GRID CONNECTIVITY TO TFL TO SUPPLY 90 MW POWER AND
CONSTRUCTION OF 220 KV LILO GIS

AMENDMENT – IV

NIT, No. PNMM/PC-183/E-4017/NCB Dated 20.06.2022

Sub.: GRID CONNECTIVITY TO TFL TO SUPPLY 90 MW POWER AND CONSTRUCTION OF
220 KV LILO GIS AT TALCHER FERTILIZERS LIMITED, TALCHER, ODISHA

PMC	PTC INDIA LIMITED				
TITLE	220/33kV GIS SUBSTATION SINGLE LINE DIAGRAM FOR ACDB & DCDB				
CLIENT	TALCHER FERTILIZERS LIMITED				
SIGN	DATE	REVISION	DATE	DRG.NO.	SIGNATURE
DRN.BY-	KNR	07.04.2022	FOR APPROVAL		
CHN.BY-	KNR				
APP.BY-

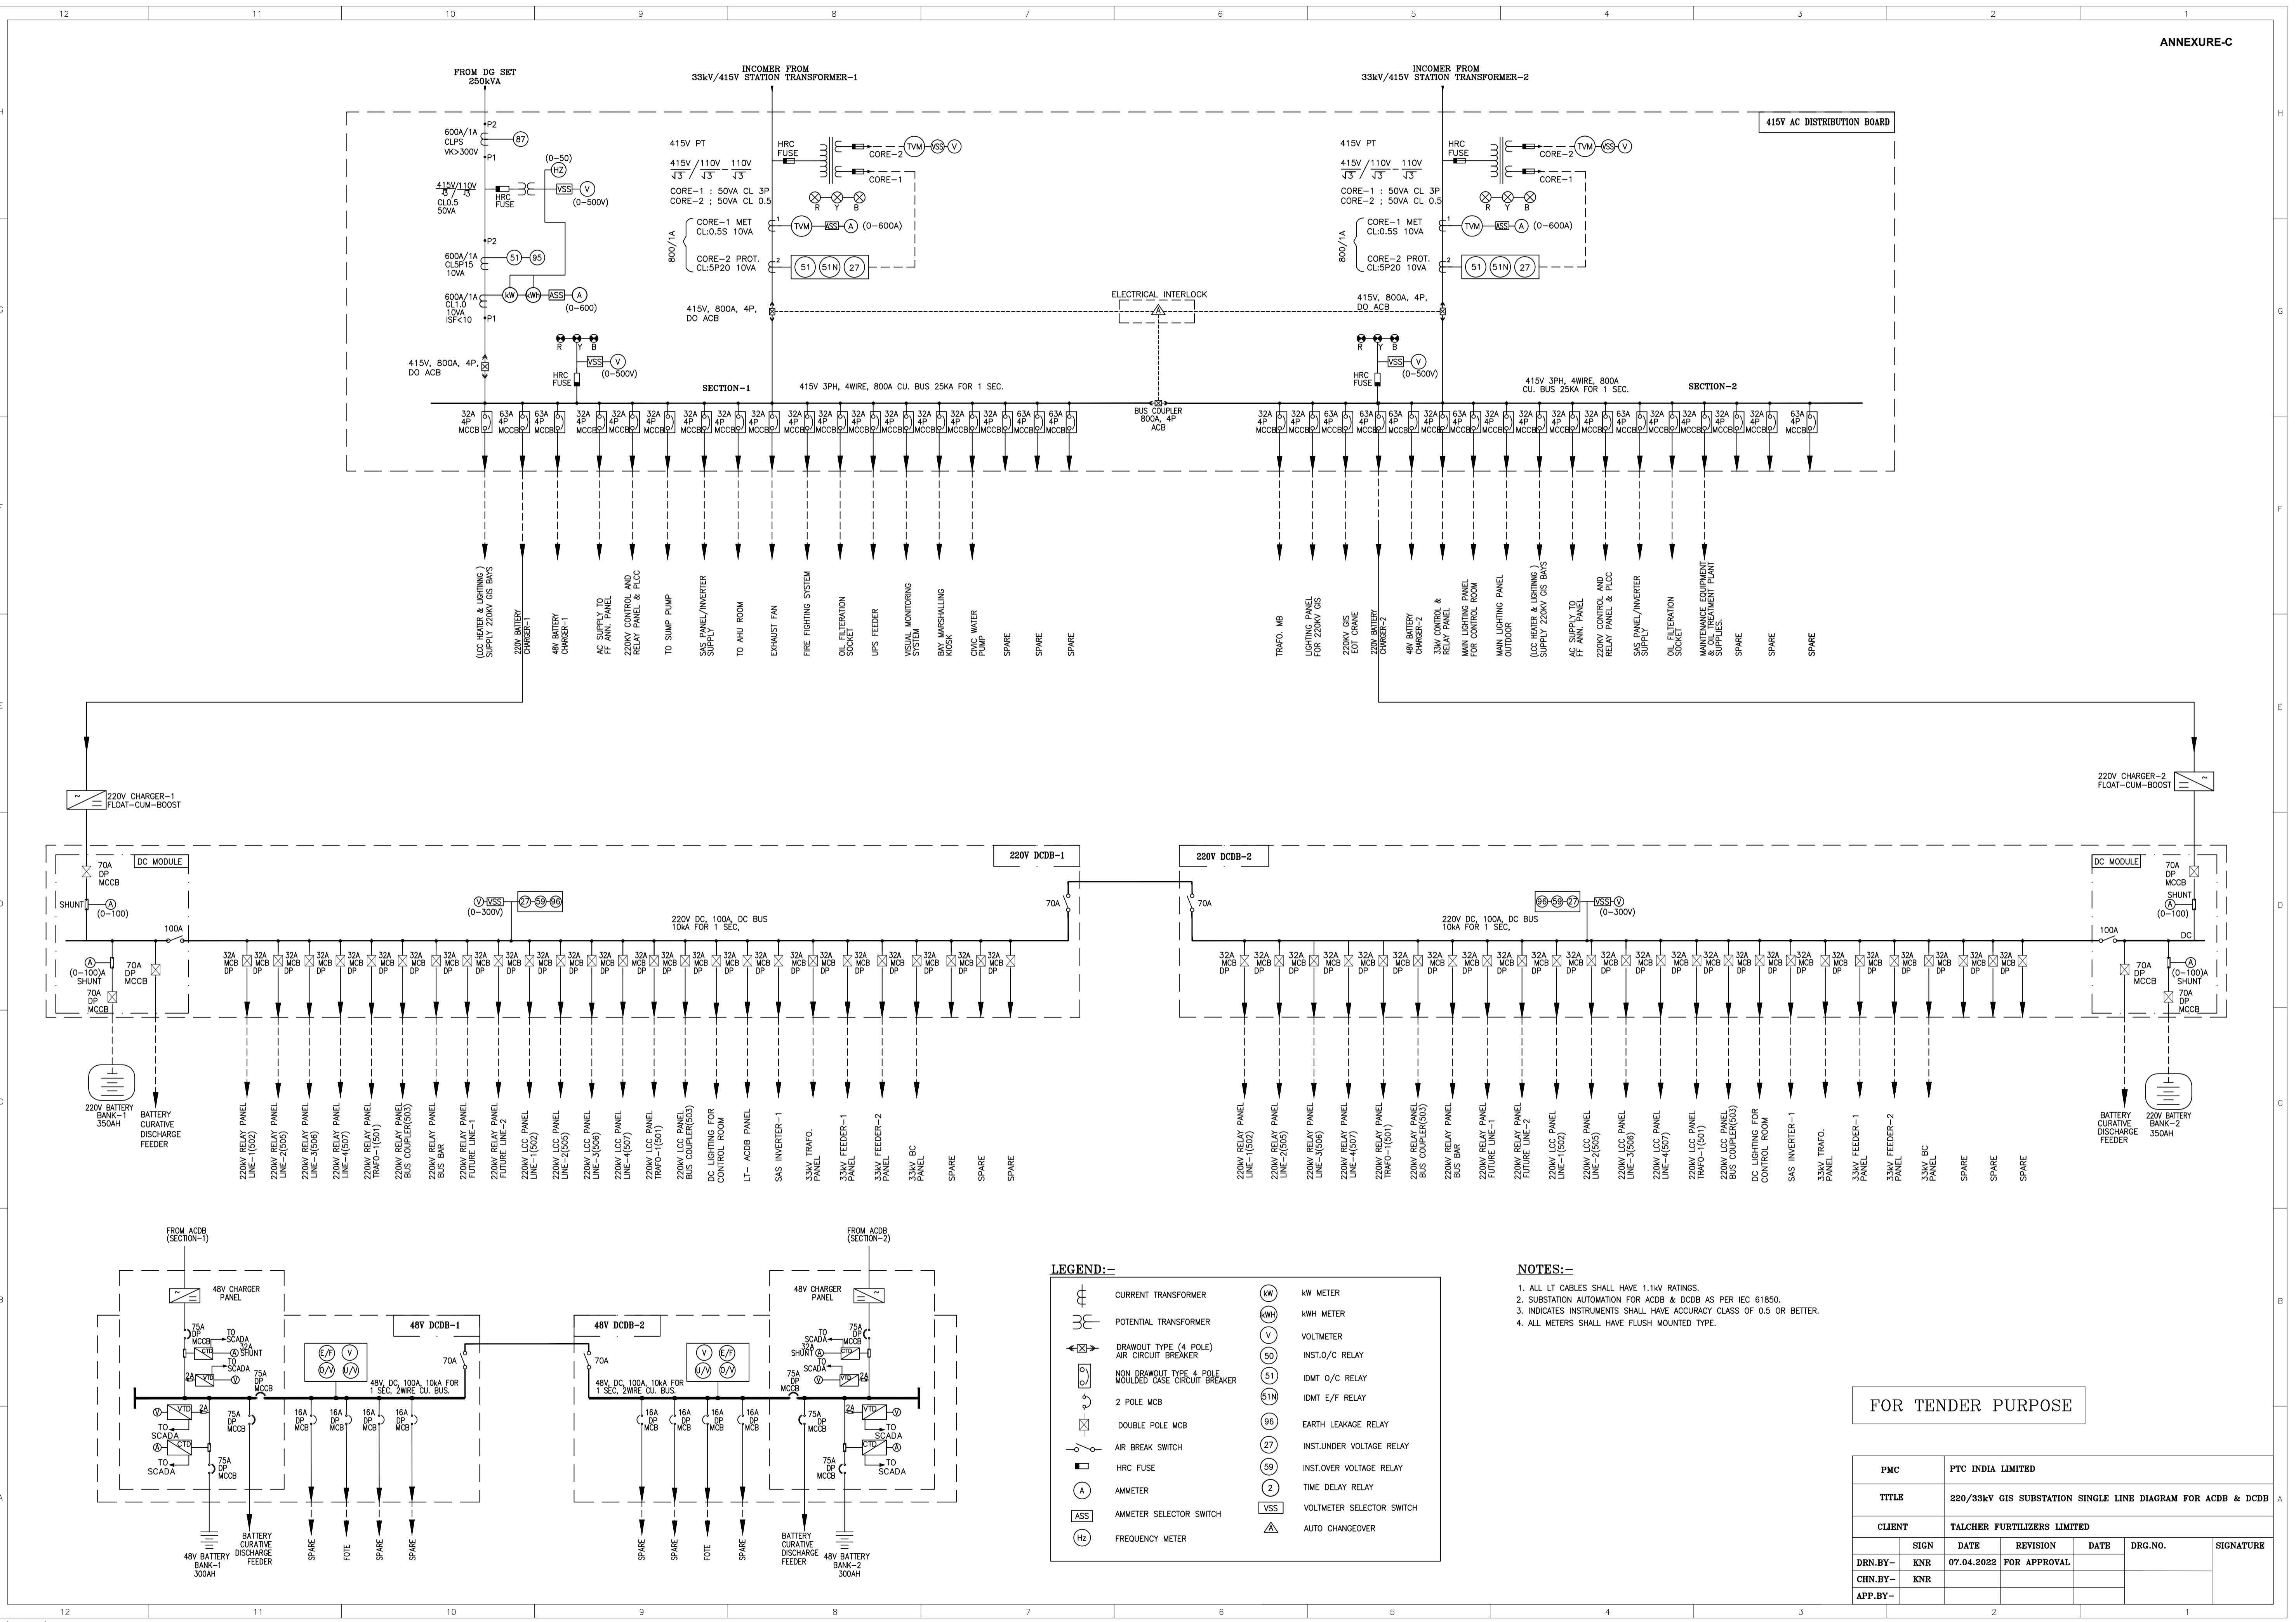
4)	TS	1615 of 1622	Annexure X – IV	Tender Drawings	LT (ACDB & DCDB) SLD	A	Refer Annexure C – “LT (ACDB & DCDB) SLD”
5)	TS	1615 of 1622	Annexure X – IV	Tender Drawings	Sectional Drawing of Switch Yard Cable Trenches	A	Refer Annexure D – “Sectional Drawing of Switch Yard Cable Trenches”

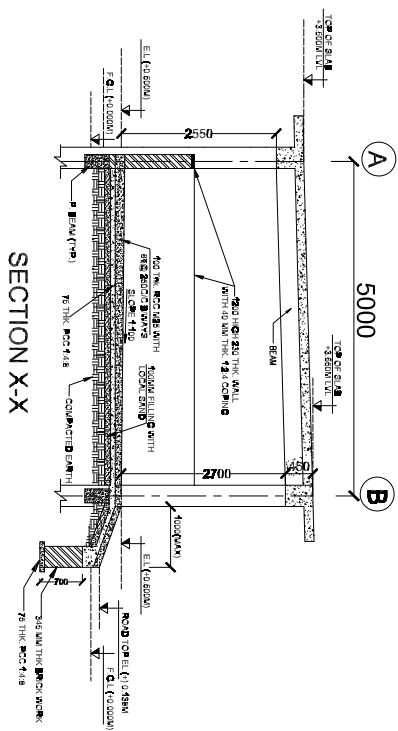
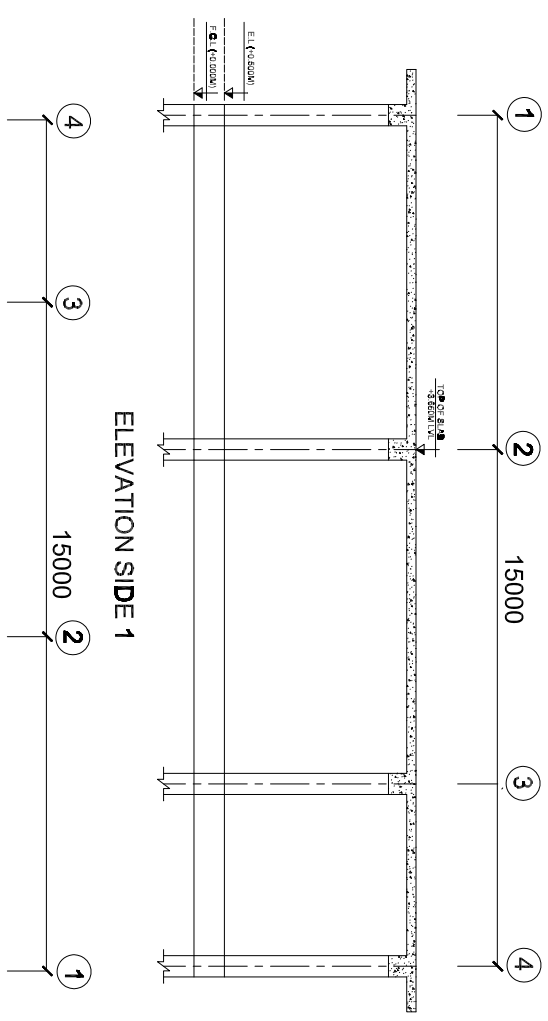
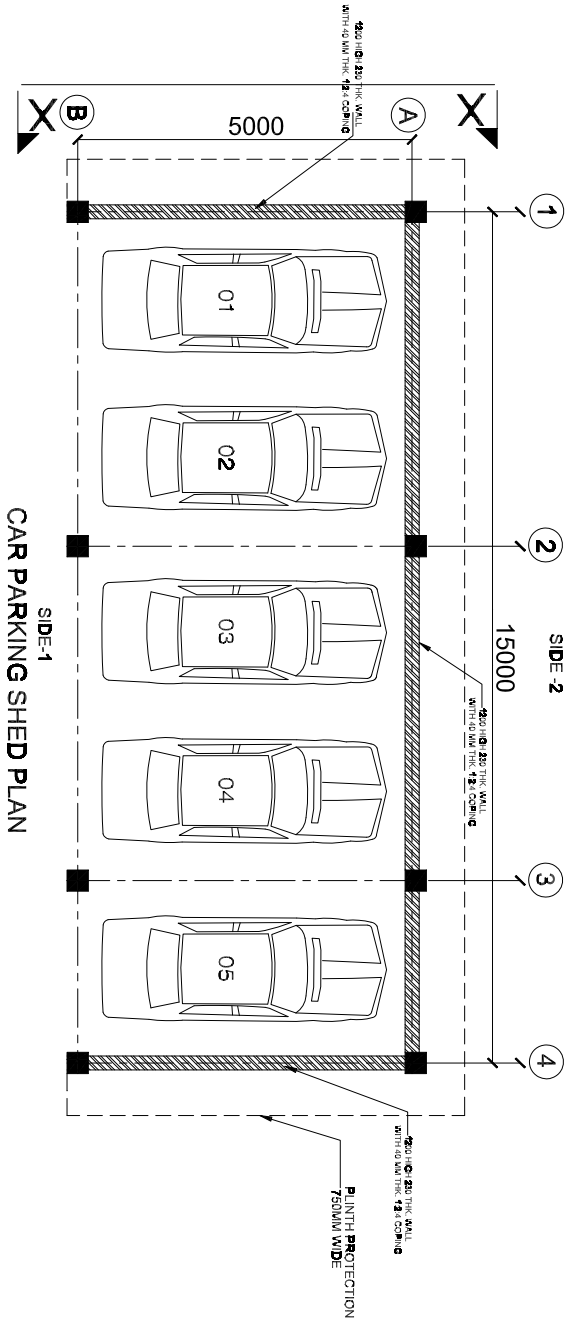
6)	TS	1615 of 1622	Annexure X – IV	Tender Drawings	Tender Reference Drawing of Car Parking Shed	A	Refer Annexure E – “Tender Reference Drawing of Car Parking Shed”

- Notes:-**
1. ALL DIMENSIONS ARE IN MM.
 2. DO NOT SCALE THE DRAWING. FOLLOW WRITTEN DIMENSIONS ONLY.
 3. DRAWING FOLLOWS TENDER PURPOSE ONLY.
 4. ALL DIMENSIONS ARE TO FACE UNLESS SPECIFIED OTHERWISE.
 5. TOTAL STORE ROOM LENGTH AND BREADTH = 10000MM (AREA=100SQM).

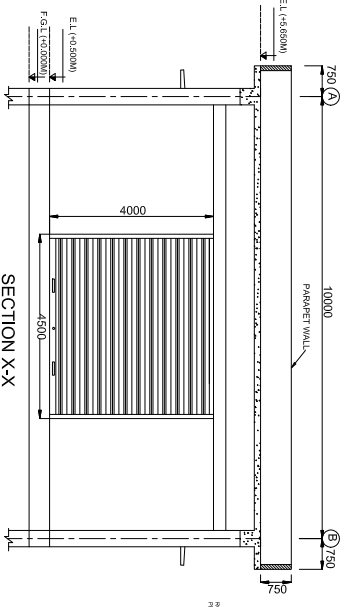
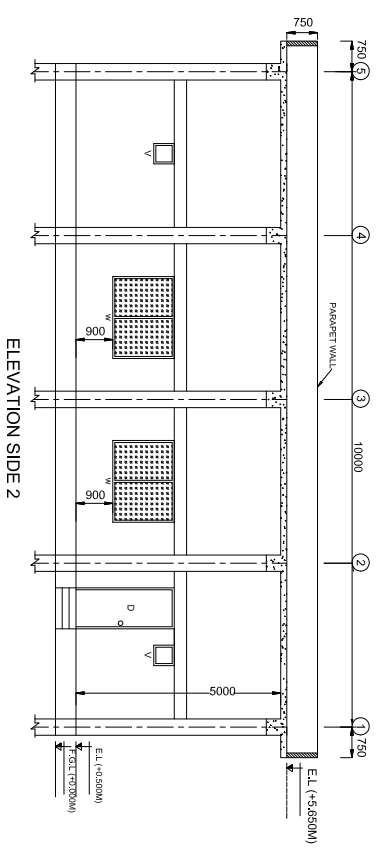
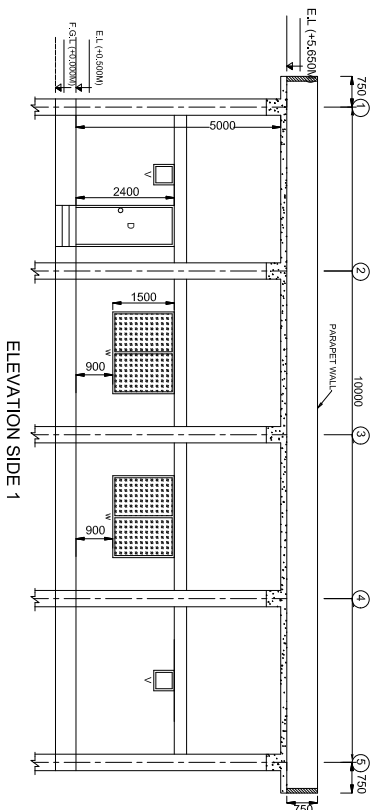
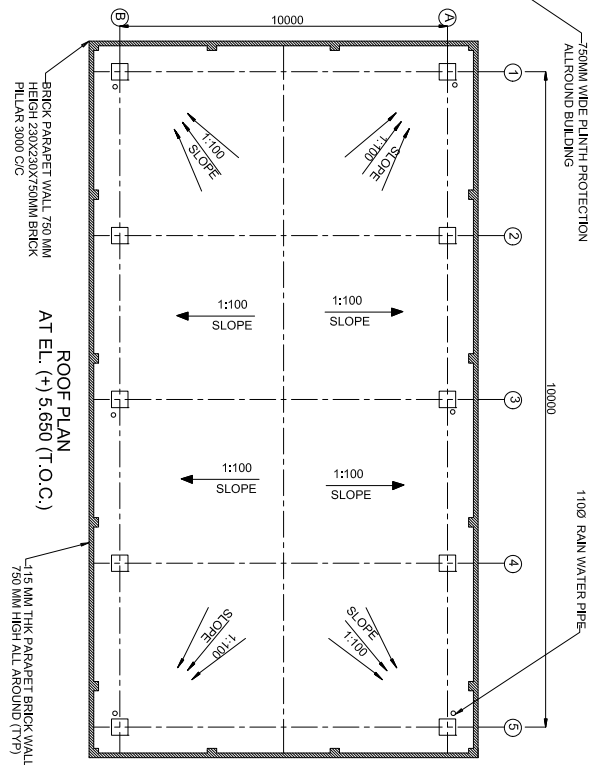
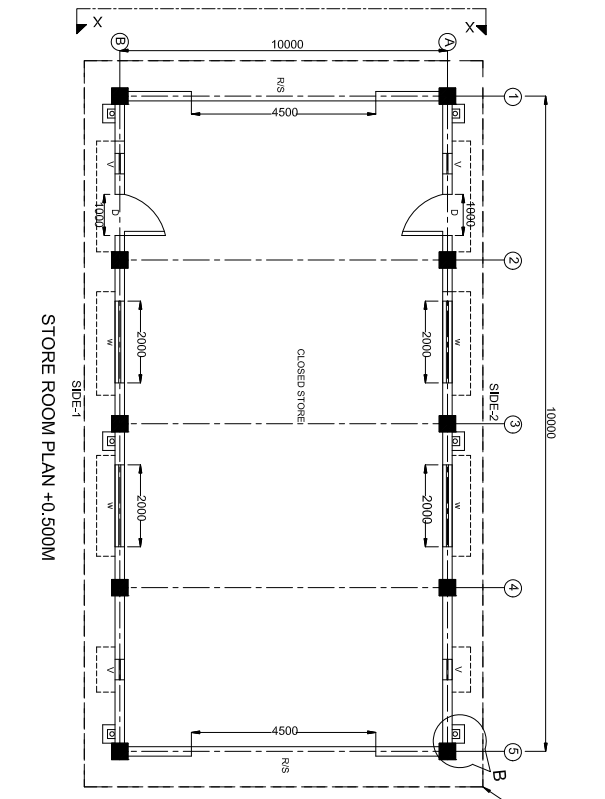
7)	TS	1615 of 1622	Annexure X – IV	Tender Drawings	Tender Reference Drawing of Store Room	A	Refer Annexure F – “Tender Reference Drawing of Store Room”
